TECHNICAL NOTE 1

DATE:	27 April 2023	CONFIDENTIALITY:	Confidential
SUBJECT:	Wind Microclimate Review - WSP response		
PROJECT:	Berol Quarter	AUTHOR:	AMcL, JVC
CHECKED:	JNM, CD	APPROVED:	CD

Further to the submission of the Wind Microclimate report issued in November 2022 for the Proposed Development of the Berol Quarter, comprising the Berol House and 2 Berol Yard buildings, WSP have been asked to provide clarifications in relation to the wind assessment. An independent review of the wind assessment has been carried out by ArcAero. The review concludes that the assessment represents a plausible appraisal of the wind microclimate upon the introduction of the Proposed Development. A number of queries and requests for clarification have been raised, but the assessment and associated predictions appear reasonable, and as such, it is expected that provided satisfactory clarification and / or further details, the conclusions can be considered to be robust.

Figure 1: Input and measured velocity profile

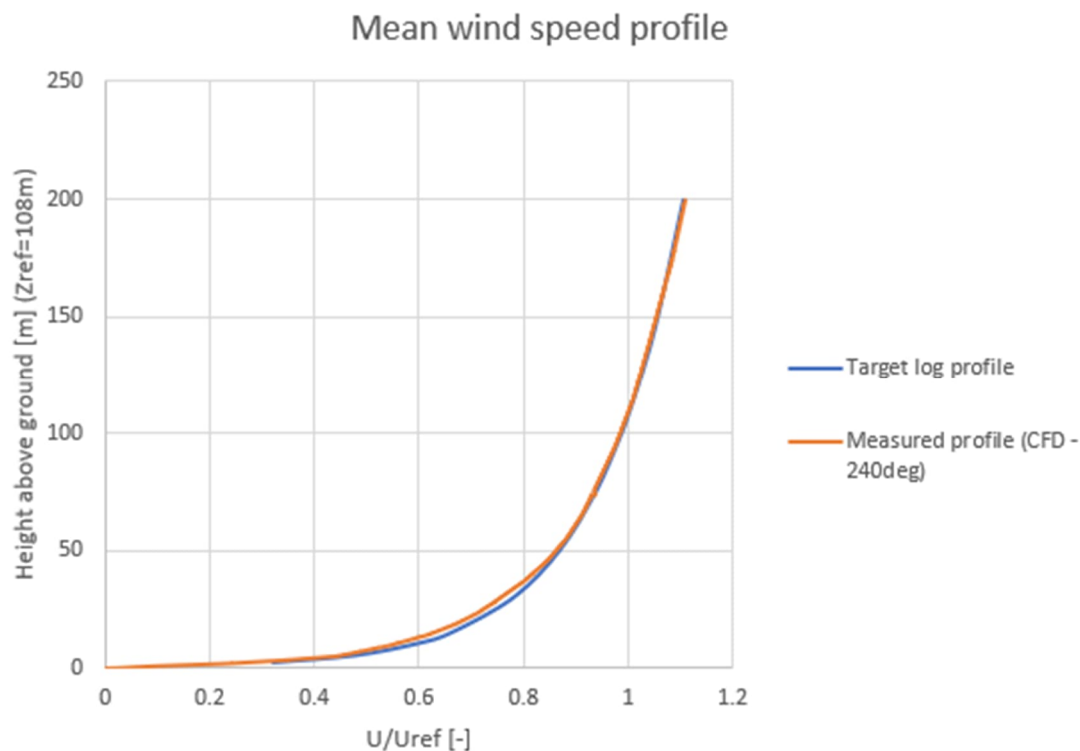
Query 1.1.b *Please provide the simulated and targeted profile for the CFD simulation*

Response: Figure 1 shows a comparison between the target profile and the measured profile in the simulations for the 240° wind direction.

Figure 2: Contours of comfort using CFD with point data from a wind tunnel test

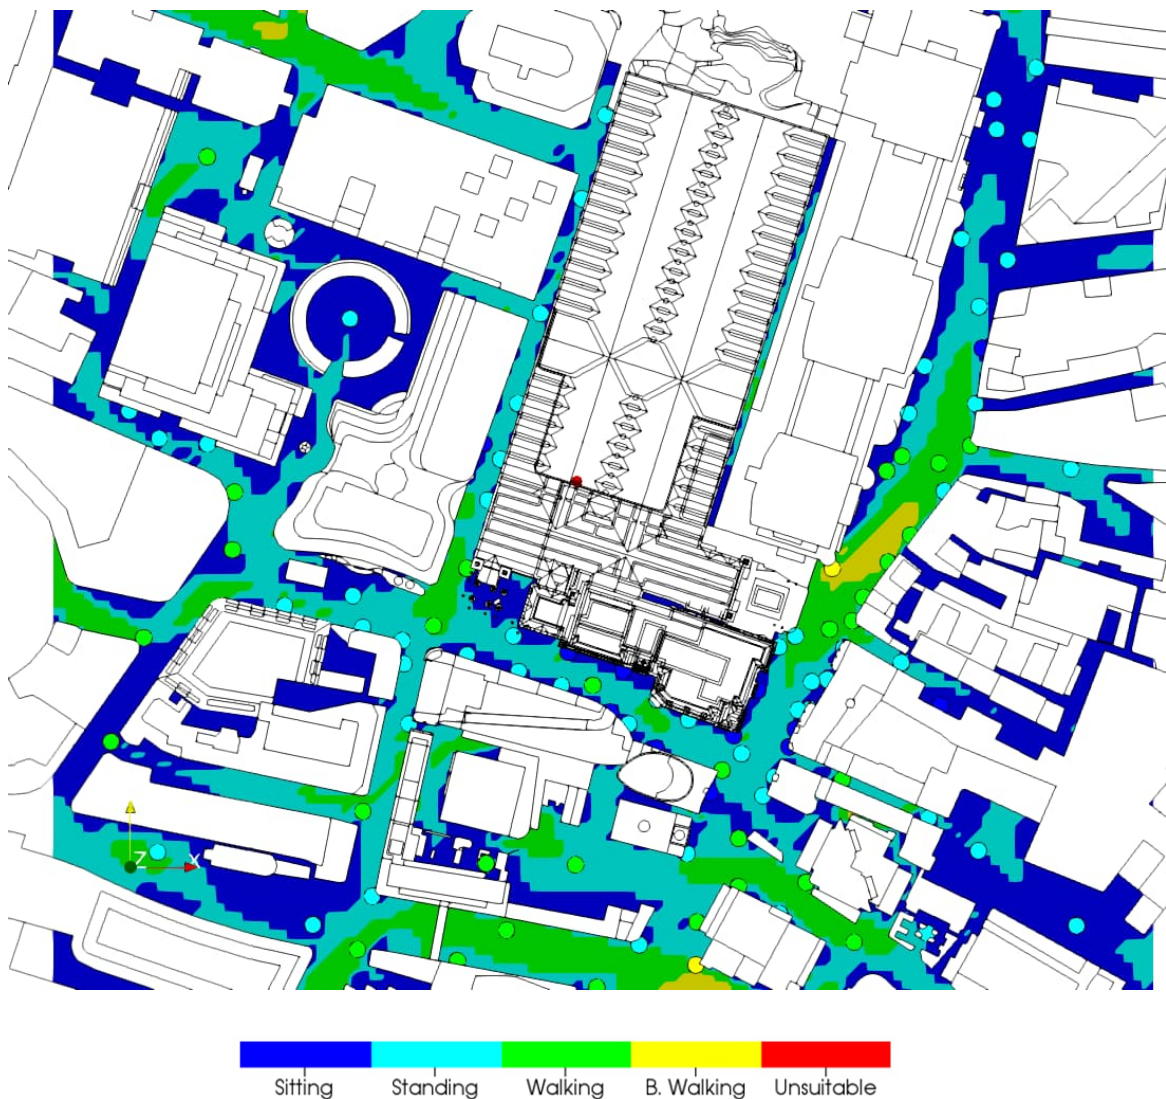
Query 1.2 Clarification is sought as to why a CFD only approach was selected for this assessment. In addition, it would provide some confidence in the assessment if a comparison between CFD results and wind tunnel results could be provided.

Response: Based on WSP's experience and professional judgment, the adoption of CFD was considered appropriate for this assessment. WSP have extensive experience both in wind tunnel and CFD testing, including many projects where both methods are used. A typical output of the two models is shown in Figure 2 for a different project, performed at a similar time to this assessment, utilising an identical gust model as the gust model used in the current project, showing a good agreement. The plot shows qualitatively comparable results between CFD and WTT for a more complex geometry with much taller buildings. The results in our example comparison between CFD and WTT shown in Fig 2 are well within the normal variation we would expect between consultants. WSP are confident that the agreement proves that the choice of analysis tool does not affect conclusions drawn from the results.

Figure 3: Contours of annual comfort at 1.5m above local ground

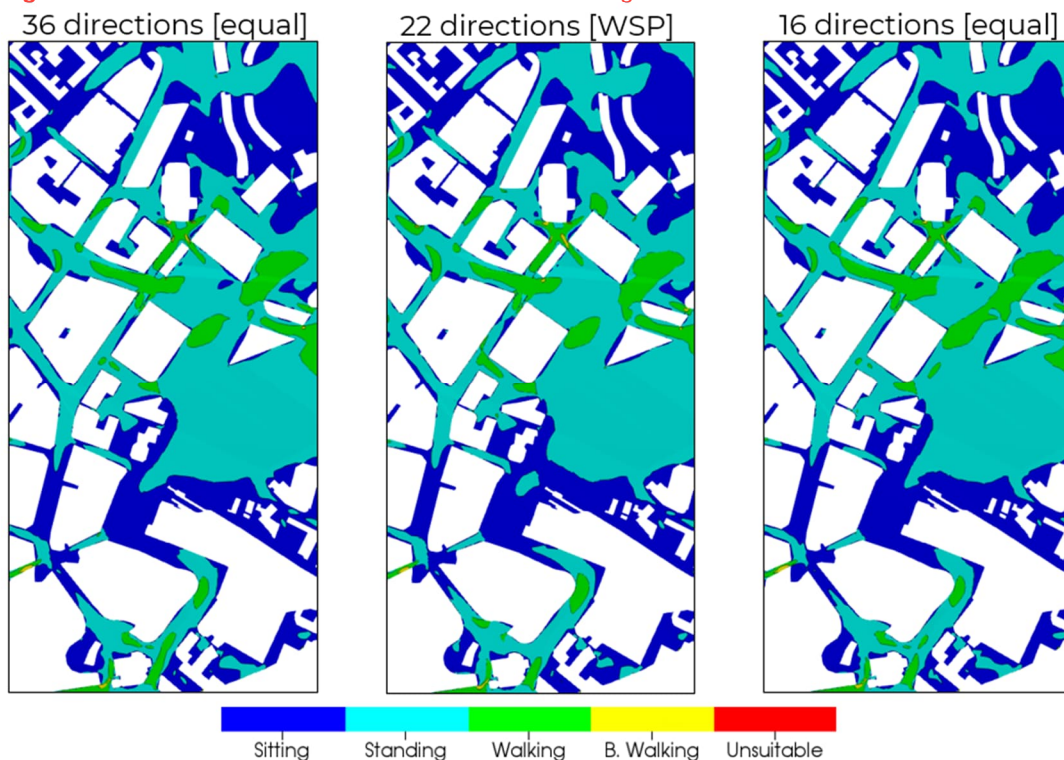
Query 1.8 *Please clarify if the “Combined frequency [%]” values in Table 3-6 correspond to the “p” values within paragraph 3.6.4, and please clarify the methodology used to select the c and k values for the simulated wind directions that consist of grouped wind directions (ie, was it the maximum / minimum / average of the c and k values that were selected?).*

Response: The ‘c’ and ‘k’ terms are averaged over the bin. Extensive testing has been carried out to verify the accuracy of this method. The plot below shows the results of one of our studies into the directions binning and averaging of the c and k Weibull terms. Results for 36 directions have c and k values for each 10degree segment and 22 directions have c and k values averaged across the bin. Results are near identical.

Figure 3: *Contours of comfort in winter for elevated levels*

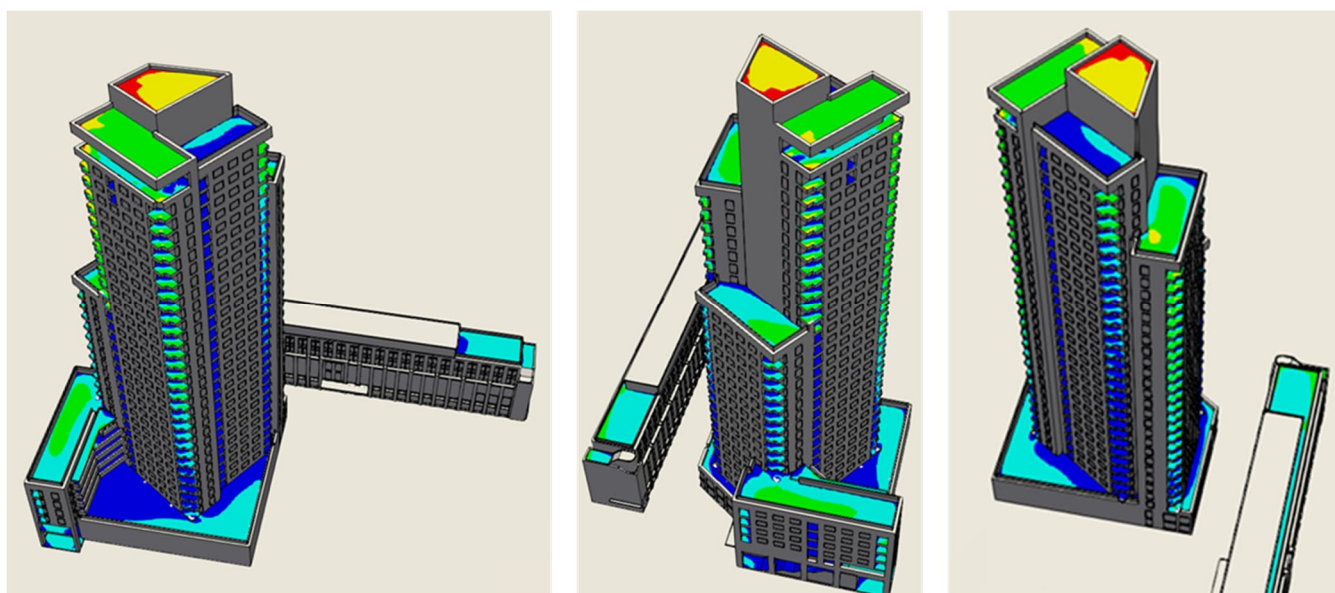
Query 2.2 *Provide comfort criteria contour plots of elevated terraces in winter (or worst-case seasonal), to assess the conditions at the entrances to the elevated terrace areas.*

Response: All entrances to accessible terraces at elevated levels are suitable at least for standing. Contour plots of elevated terraces in winter are provided in Figure 3 below.

Figure 4: Contours of comfort in winter for street level highlighting the conditions at the Tottenham Hale Bus Station (Stop F)

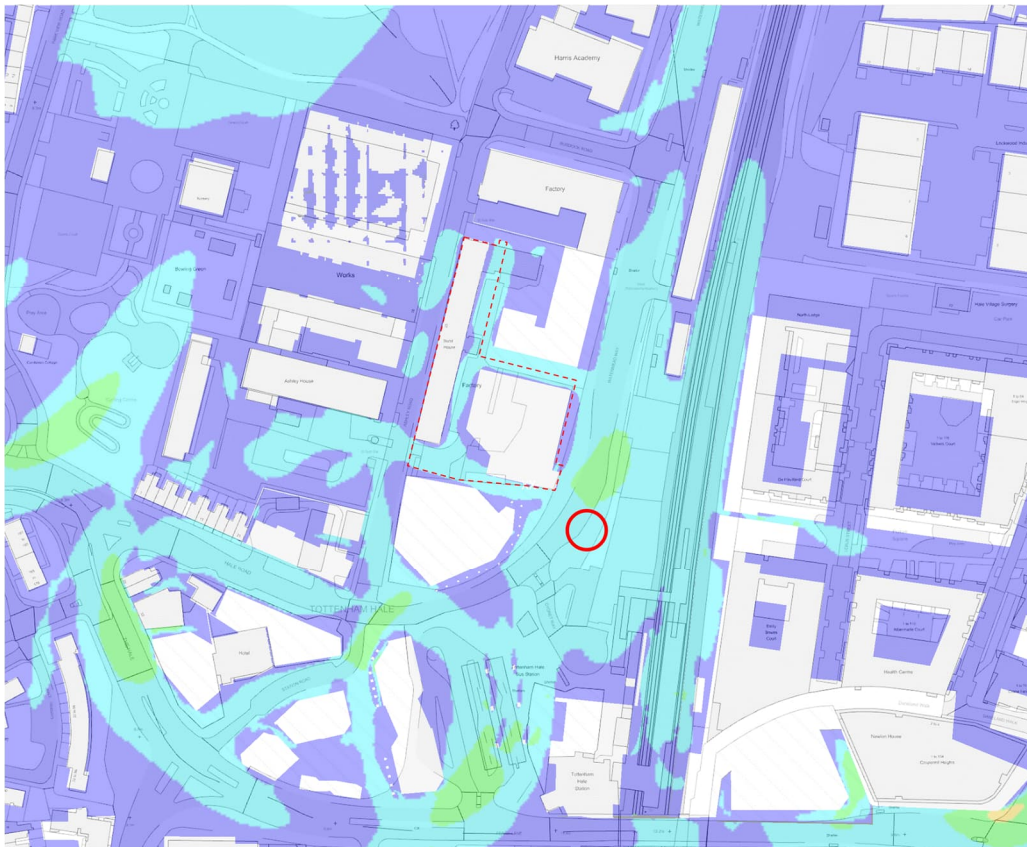
Query 2.6 *Please clarify if this region of leisure strolling conditions overlap with this bus stop area, and if such, mitigation measures will need to be recommended and validated for this area.*

Response: The region of leisure strolling conditions does not overlap with the bus stop area and as such, the wind conditions remain suitable. Contours of comfort in winter for street level highlighting the conditions at the Tottenham Hale Bus Station (Stop F) are provided in see Figure 4.

Figure 5: Contours of comfort in winter highlighting location 26 (circled)

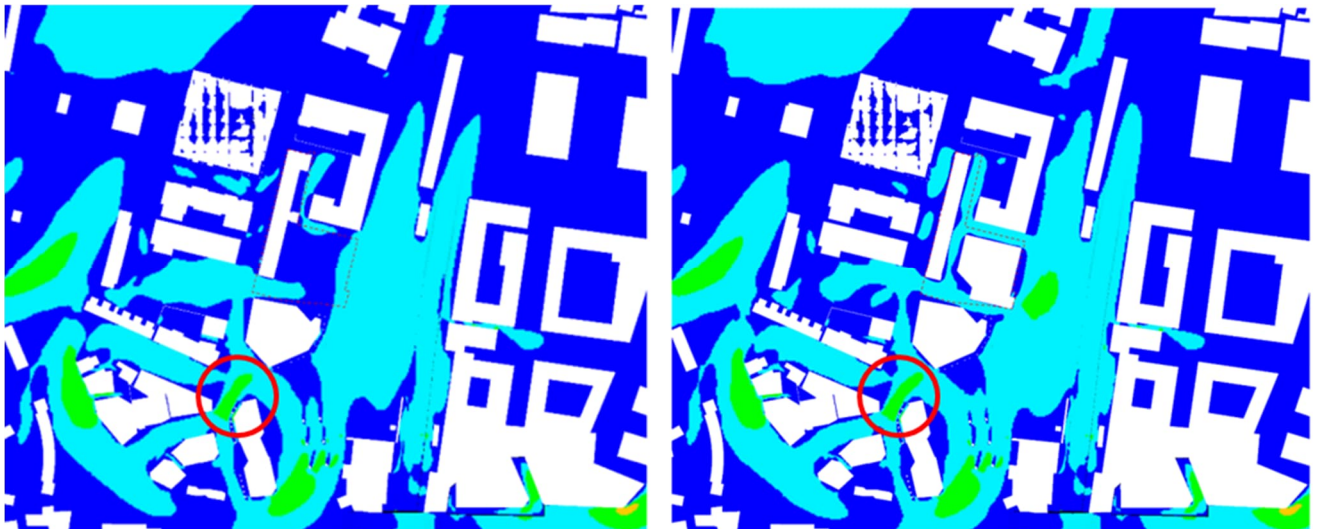
Query 2.9 *If WSP are able to demonstrate that the business walking area adjacent to location 26 is not due to a contribution from the Proposed Development, the results as presented will be considered as plausible and will be accepted.*

Response: The region of leisure walking adjacent to location 26 is not due to a contribution from the Proposed Development as this effect was present in the Baseline Scenario (existing conditions). The same applies to location 35 which reports business walking. Contours of comfort in winter for street level highlighting the conditions at location 26 are provided in Figure 5.
